RENESAS TECHNICAL UPDATE

Product Category	System LSI		Document No.	TN-RIN-A016A/E	Rev.	1.00
Title	Ethernet MAC reception issue in case TCPIP accelerator enabled		Information Category	Technical Notification		
Applicable Product	Please refer to [1. Applicable Product] described below.	Lot No.	Reference Document	R-IN32M4-CL2 User's Manual: Peripheral Modules R9J03G019GBG Rev1.00 (R18UZ0034EJ0100)		
		All lot

Fig1: Flowchart of RX FIFO overflow processing task (In case of using HW-RTOS)

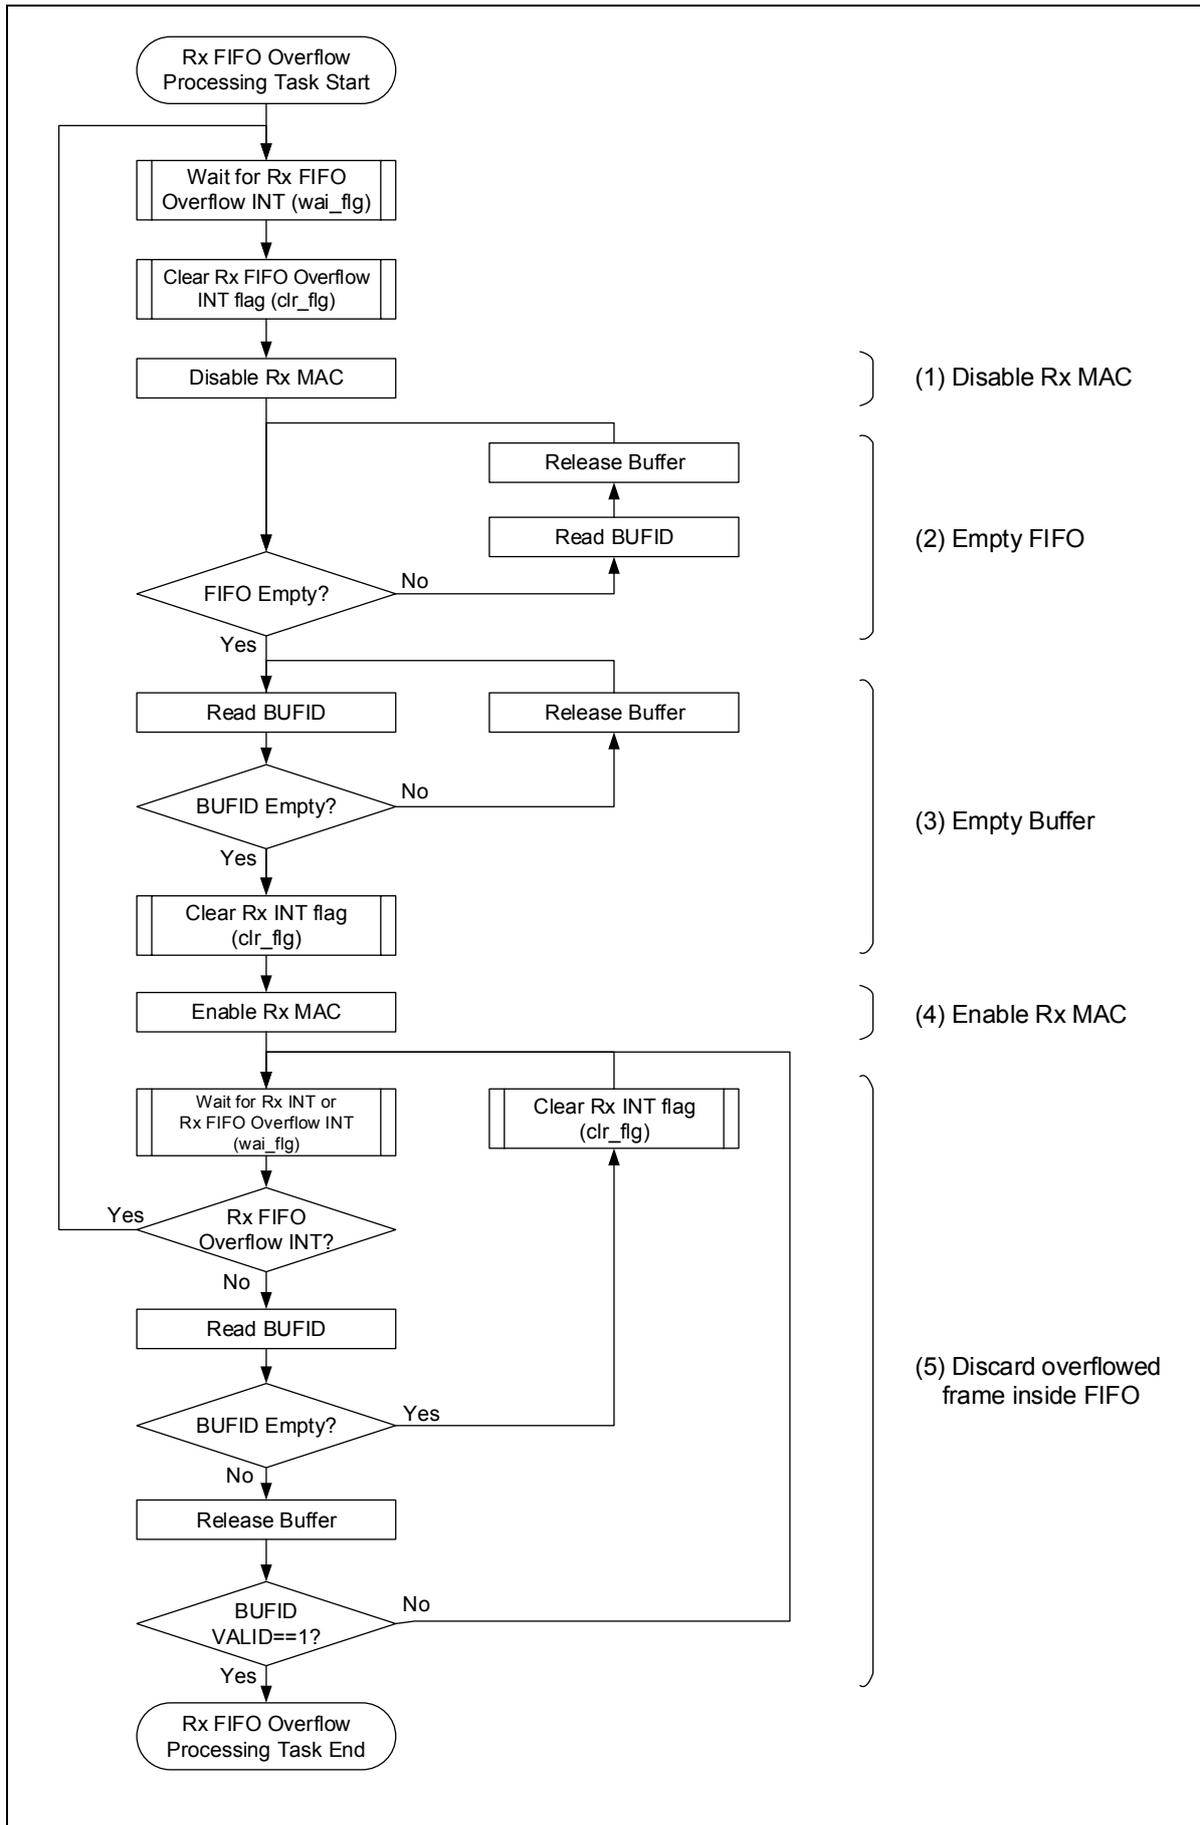
- It is possible that error information which is related to the previous error frame is included in frame information of normal reception frame.
- It is possible that abnormal frame which caused Rx FIFO overflow is regarded as normal frame because of illegal value is included in frame information

In case Rx FIFO overflow is occurred when Rx TCPIP accelerator is enabled.

- (A) Disable Rx TCPIP accelerator without padding insertion to MAC header. Specifically, clear bit0 of GMAC_ACC register.
- (B) When Rx FIFO is overflowed, discard all frames left in Rx FIFO and Buffer RAM. Specifically, apply the following procedure;
 - (1) Disable Rx MAC.
 - (2) Discard all frames inside Rx FIFO.
 - (3) Discard all frames inside Buffer RAM.
 - (4) Enable Rx MAC.
 - (5) Discard at least one frame with BUFID VALID bit = 1. This is because FIFO empty state can be read even if the frame which caused FIFO overflow remains in the FIFO. Receive normal frame once and discard remained abnormal frame with it.

- ✓ Create overflow processing task with higher priority than one of reception processing task
- ✓ Start overflow task by HWISR combined with FIFO overflow interrupt
- ✓ Discard the abnormal frame remained in the FIFO by HWISR combined with reception interrupt

Fig 5: Flowchart of Reception processing

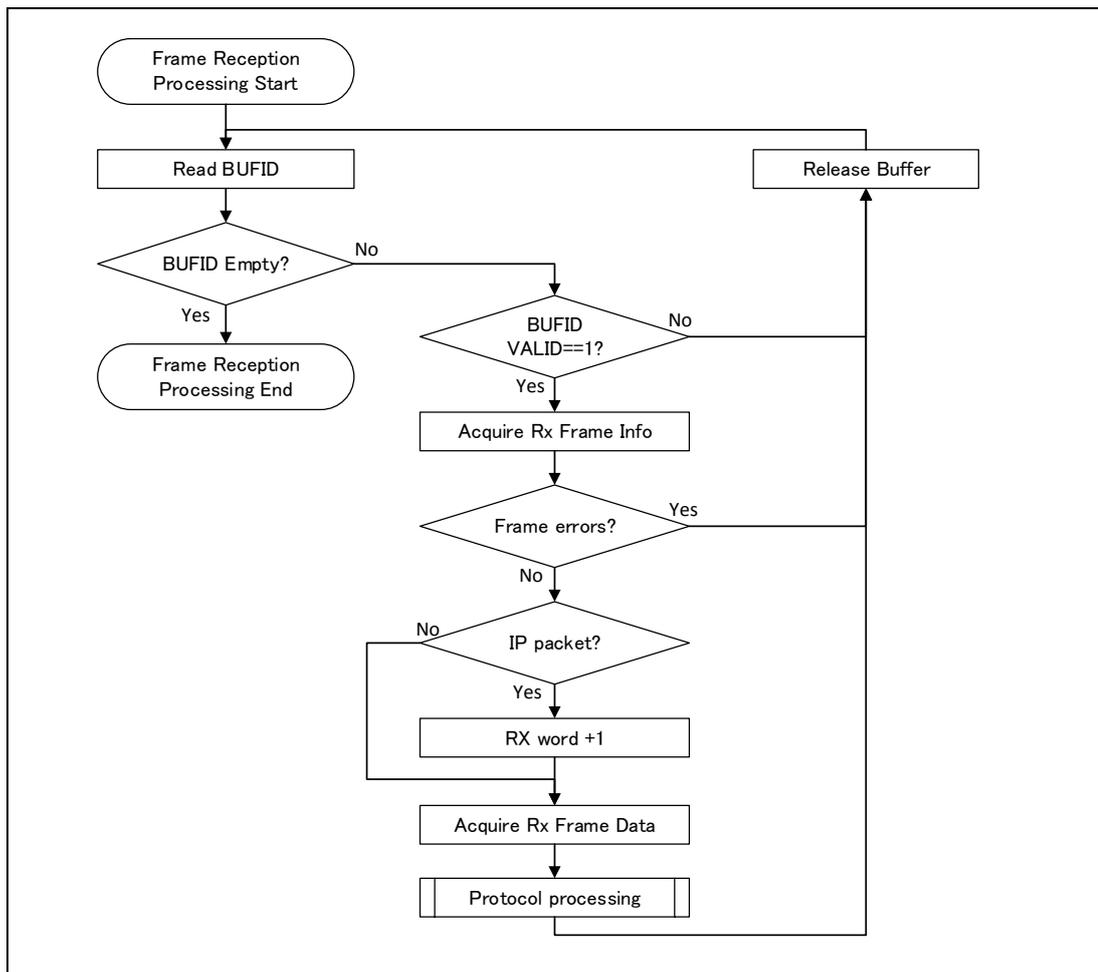
It is possible that reception word size (RX_WORD[12:0]) in the frame information increases by 1 word (4 bytes) or decreases by 1 word compared with correct size. In case of decrease by 1 word, it is possible that RX_WORD indicates the size which causes lack of IP packet. IP packet itself is NOT lacked.

- (A) RX TCPIP accelerator enabled
- (B) Reception frame meets all the following conditions;
 - (1) Frame size including FCS is more than 64 bytes.
 - (2) TCP/IP or UDP/IP packet is included.
 - (3) Padding (Trailer) is included between IP packet and FCS.

- (A) Disable Rx TCPIP accelerator. Specifically, clear bit0 or set bit2 of GMAC_ACC register.
- (B) In order to avoid lack of the IP packet, increase reception word size by 1 and transfer the size to protocol stack. In the protocol stack, payload data should be extracted based on size of Total Length field in IP header and the rest data should be discarded. Fig 5 is the flowchart of this workaround.
